To: Torsten Lohoff, null
From: Joe Dichoso
jdichoso@fcc.gov
FCC Application Processing Branch

Re: FCC ID O2OSYN8705A
Applicant: Digianswer A/S
Correspondence Reference Number: 17512
731 Confirmation Number: EA99205

Plot of 20 dB bandwidth in inquiry mode = 547 kHz.

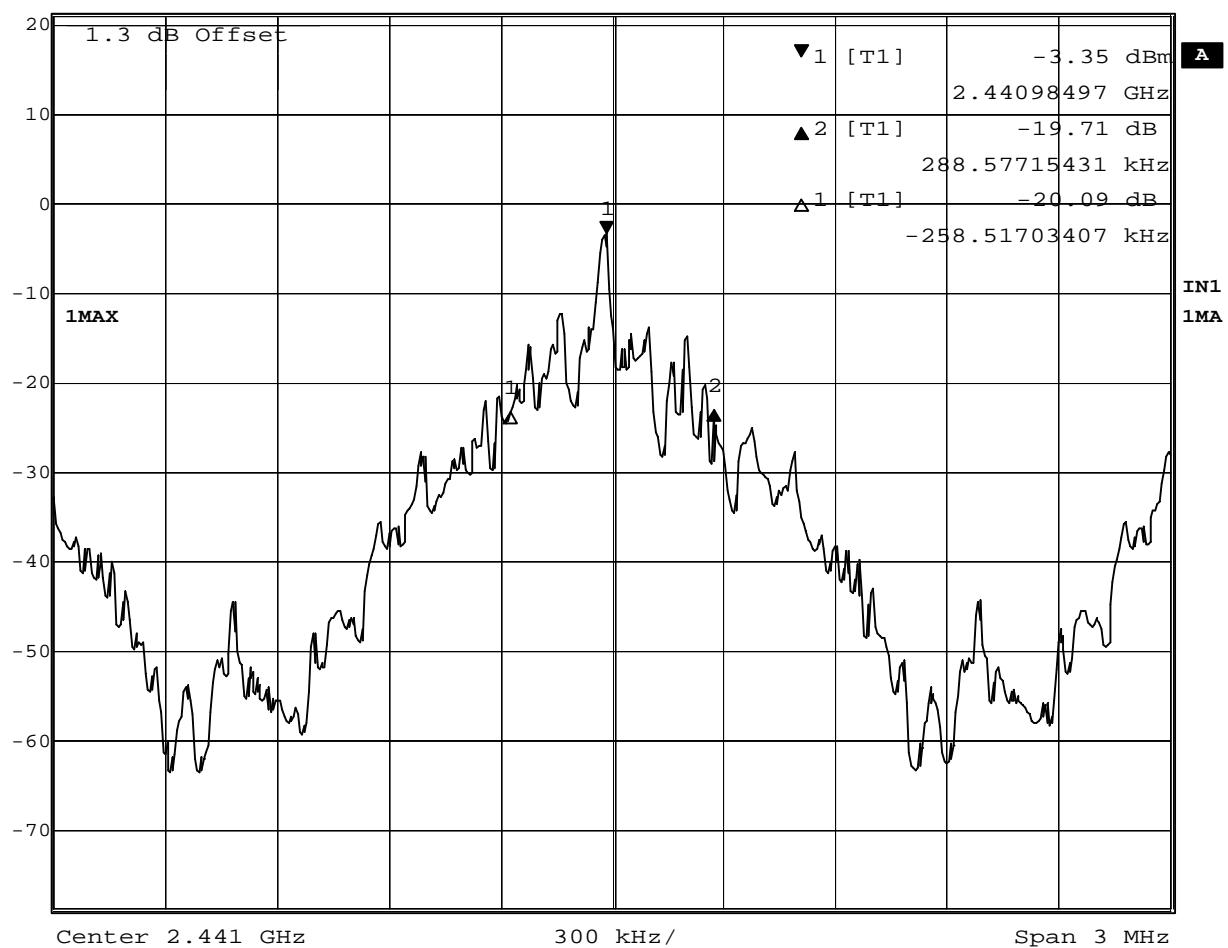
g) 20 dB bandwidth plot.
